INITIAL FIRE SAFETY INSPECTION REPORT

BABYLON GARMENTS AND DRESSES LTD (Extension)

RSC ID: 24766

Date: 24 December 2023

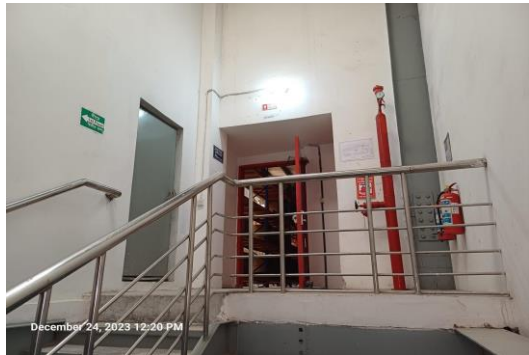
F-2	Fire Rated Construction	The exit stairs are not separated from work areas and other spaces on each floor by fire rated construction.	The exit stair enclosure shall be provided with a minimum 1-hr fire resistance rating for buildings with 3 or fewer stories and a minimum of 2- hr. fire resistance rating for buildings 4 or more stories. Provide 0.75 hr. fire rated door and seal all penetrations and openings by 1 hr. fire rated fire rated barrier construction for building with 3 or fewer stories. Provide 1.5 hr. fire rated door and seal all penetrations and openings by 2 hr. fire rated fire rated barrier construction for building with 4 or more stories. Provide a fire-resistive rated assembly between the exterior exit stairs and the building up to 10 ft. beyond the end of the stair to achieve the required separation. The rated assembly shall be approved and/or designed by a qualified fire protection engineer. Ensure that the fire doors are self-closing and positive latching and that they are provided with fire exit (panic) hardware where serving production floors. If fire doors are required to be held open for functional reasons, provide automatic closing devices tied to the fire alarm system.	Within 3 months

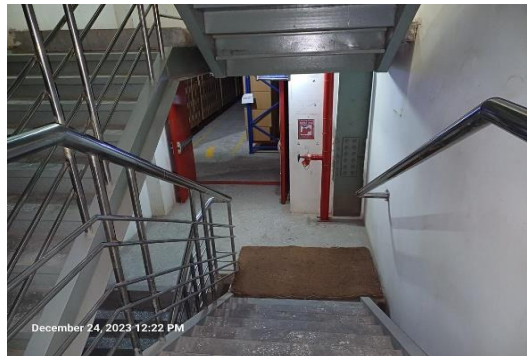
F-3	Fire Rated Construction	Store room discharged directly into the exit stair enclosures.	Openings from exit enclosure to storage shall be provided with a vestibule with fire rated construction and openings. Provide a 1 hr. fire rated door on the exit stair side and a 1- hr. fire rated door on the storage side. Ensure that the fire rating of the vestibule construction matches that of the exit stair enclosure.	Within 3 months
-----	-------------------------	--	---	-----------------

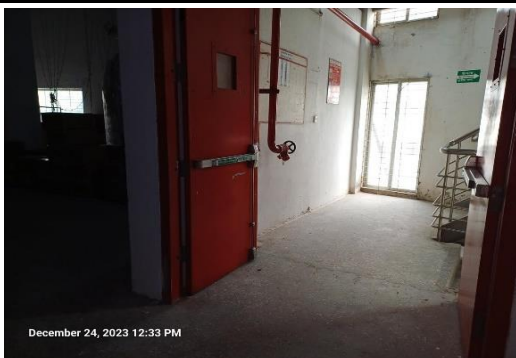
F-9	Means of Egress	Building did not have stair designation signs or occupant load signs at the required locations. Stair designation sign is found most of the places, but missing in a few locations.	Provide stair designation signs and occupant load signs at the required locations.	Within 1 month
-----	-----------------	---	--	----------------
